**STATE OF NEW YORK
PUBLIC SERVICE COMMISSION**

**Proceeding on Motion of the Commission to Implement)
Transmission Planning Pursuant to the Accelerated) Case No. 20-E-0197
Renewable Energy Growth and Community Benefit Act)**

**Comments of NextEra Energy Transmission New York, Inc. in Response to
SAPA I.D. No. PSC-19-22-00021-P – Petition of Consolidated Edison
Company of New York, Inc. for approval to recover costs of Brooklyn Clean
Energy Hub and the Public Service Commission’s Notice Seeking Comment
Issued May 13, 2022**

Figure 2. Illustrative example of cable routing to Hub

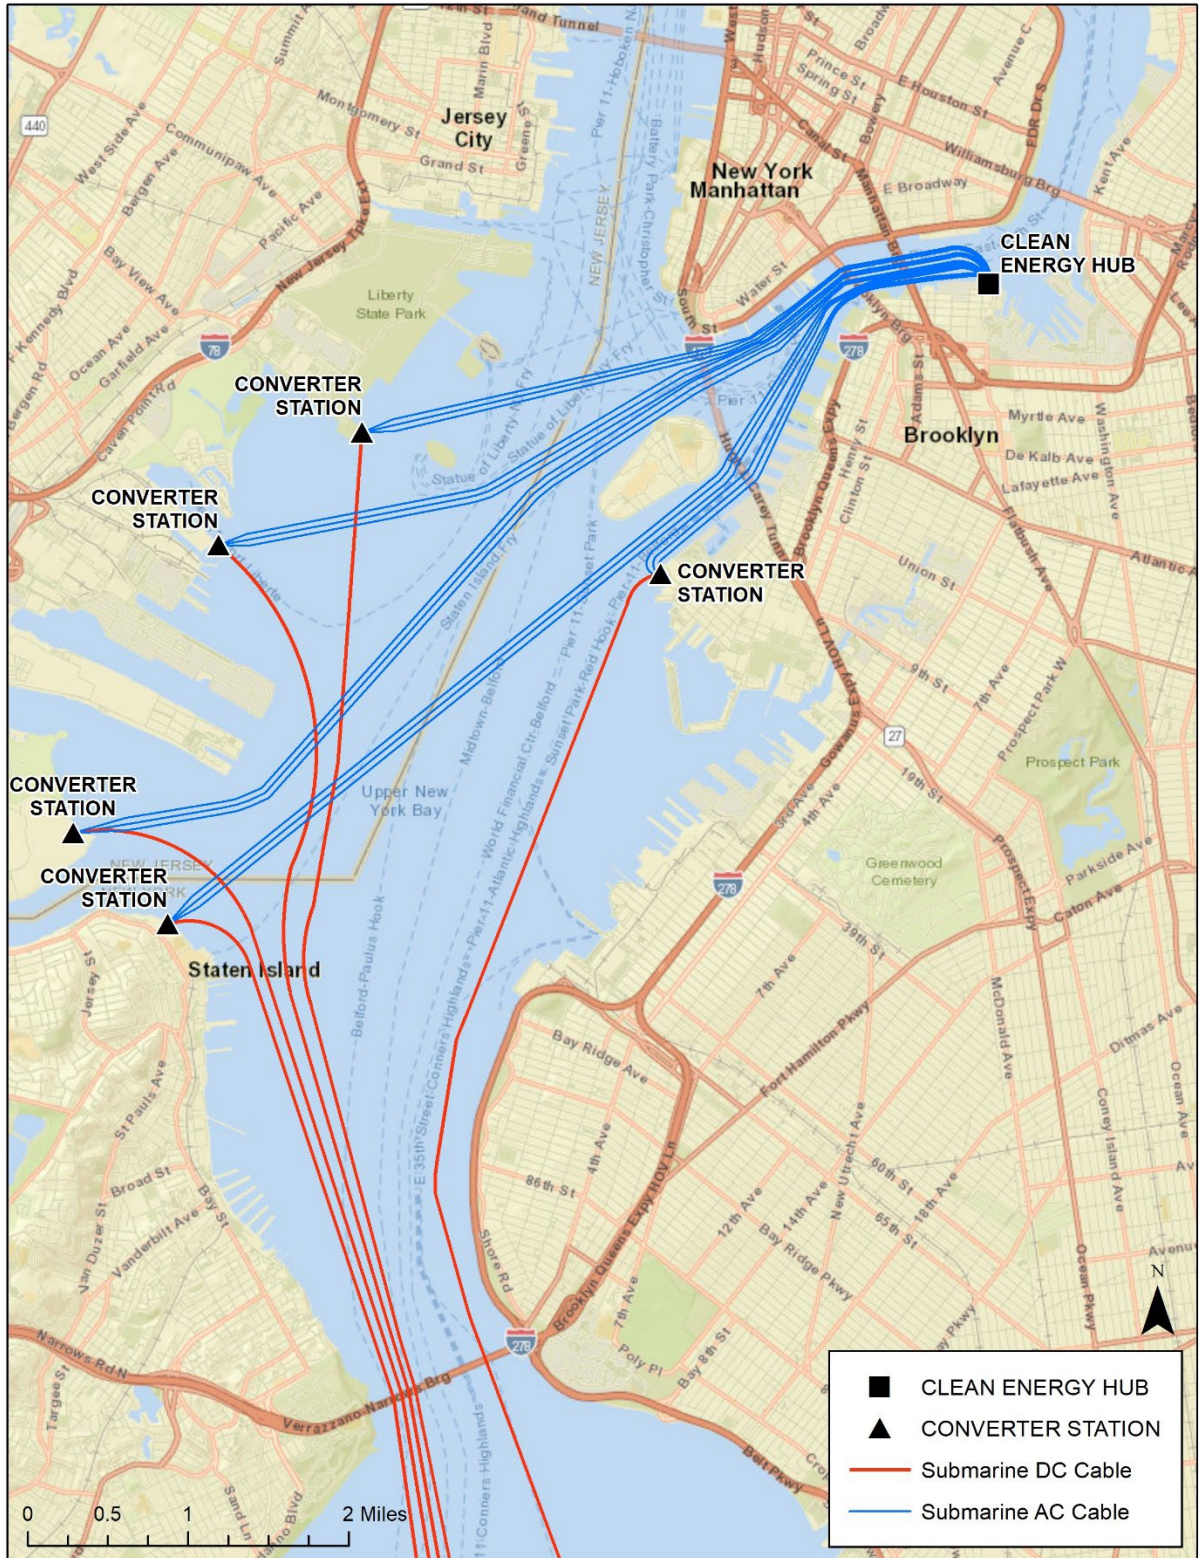
In the Petition, Con Edison assumes that OSW developers would utilize HVDC cables to reduce the number of cables required under the Verrazzano-Narrows Bridge and will site multiple converter stations near the water in New Jersey, Staten Island, and/or Brooklyn.⁵ However, under Con Edison's assumed scenario, the OSW developers would be required to install up to three HVAC cables from each converter station to connect to the Hub Project. Moreover, Con Edison assumes that the HVAC cables will connect to the Hub Project by water.⁶ To accommodate 6,000 MW of OSW generation, five (5) HVDC and fifteen (15) HVAC cables will need to be installed in the Upper Bay as illustrated in Figure 2. This large number of required cables, as well as the requirement to site and install converter stations near the water as ConEdison has proposed, presents significant coordination, permitting, and construction challenges.⁷

Figure 3. East River Constraints

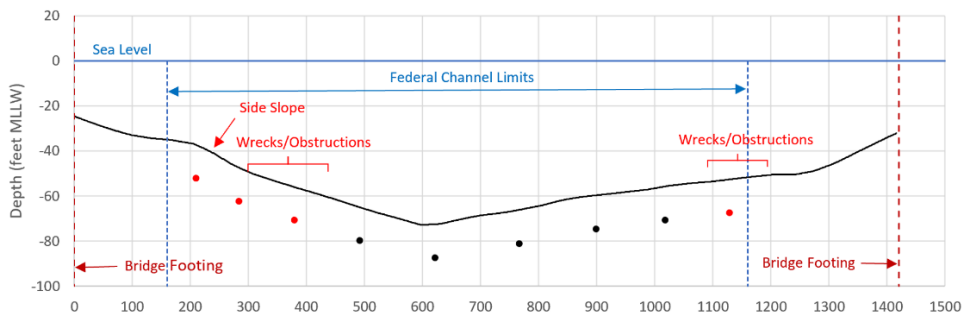
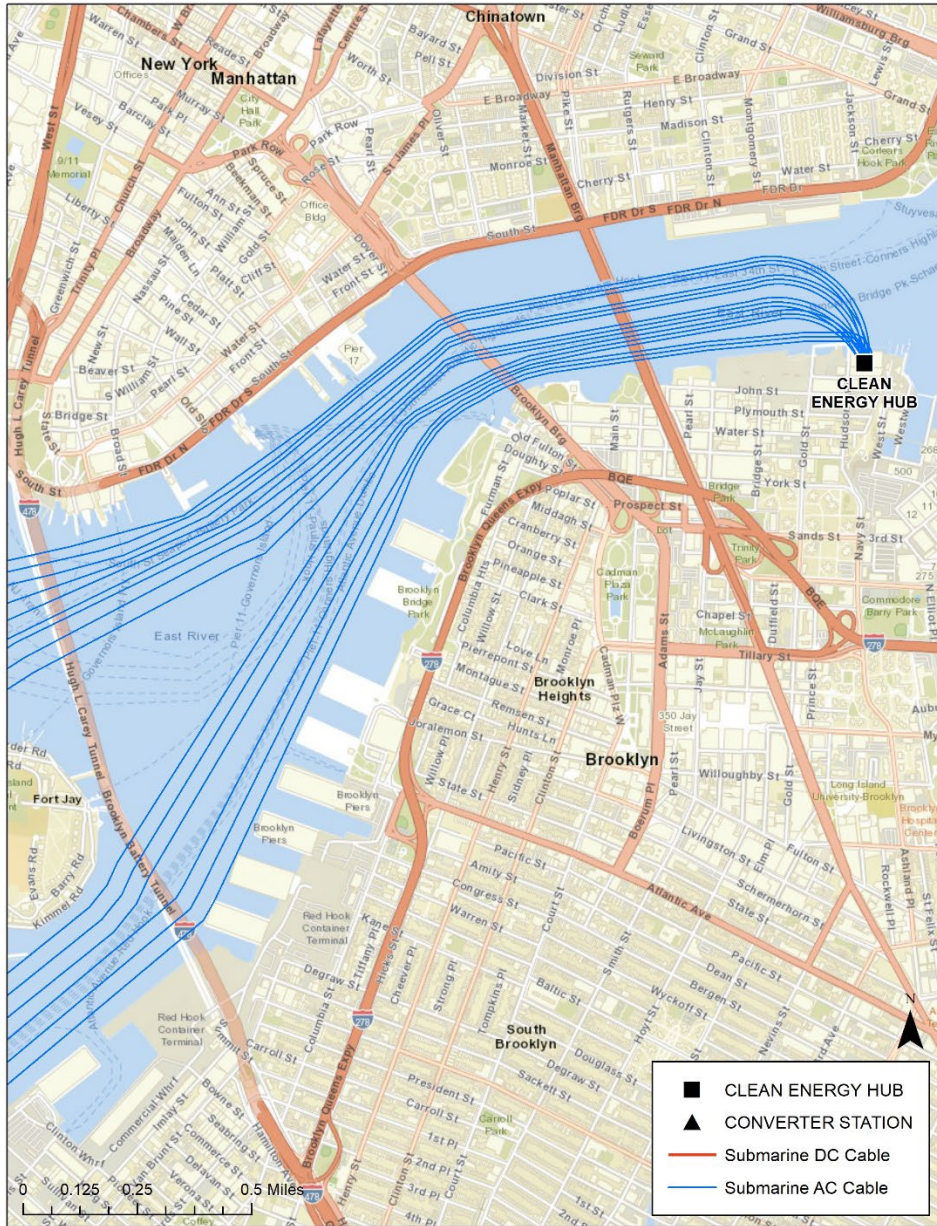
Significantly, NEETNY has performed a constructability analysis and has determined it is not possible to implement Con Edison's proposal. First, the narrow portion of the East River near the Manhattan Bridge and Brooklyn Bridge presents a physical constraint for all cables entering the East River from the south towards the proposed Hub Project location. Shoreline structures, including piers and bulkheads, extend nearly to the federal channel boundary, thus, cables would need to be installed entirely within the federal channel in this area.⁸ Siting of potential cable corridors is limited in several areas by charted wrecks and obstructions, as well as by channel side slopes approaching 20 degrees in certain areas. The standard industry practice (for maintenance reasons) is to install submarine cables in separate trenches separated by a distance equal to twice the water depth. In this area of the East River, the water depth is approximately 60 to 70 feet, meaning a cable separation of approximately 120 feet. At this recommended cable spacing, it is likely that only a maximum of five cables could be installed in the approximately 650-foot wide portion of the East River near the Manhattan Bridge.

Figure 3 below shows the relevant portion of the East River and includes a cross sectional sketch of the East River in this location to provide a visual illustration of NEETNY's analysis of the physical constraints. In this sketch, the black dots represent potential locations for cable installations.
